18 Jan 2022
22-007/ER

SD21A/0259 HOUSE AT 1 BEVERLY DRIVE, SCHOLARSTOWN RD

We are instructed by our Client to review and respond to the traffic and road elements of the Request for Further Information (RFI) issued by South Dublin County Council (SDCC) for the above development proposal i.e., item number 5.

Figure 2 – Extract TII Design Guidance

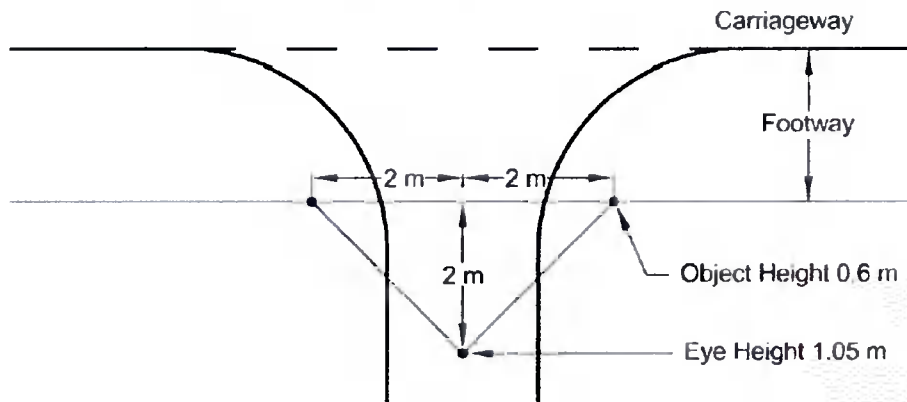
Notwithstanding the SDCC documentation, we have also reviewed the design in terms of the TII Roads Design Guidance, "Geometric Design of Junctions" (DN GEO-03060). With respect to driveways, we include below as **Figure 2** the relevant extract (paragraph 5.6.3.7) in terms of the appropriate design to provide visibility to pedestrians on a footpath.

We confirm that the proposed access will meet and exceed these design requirements
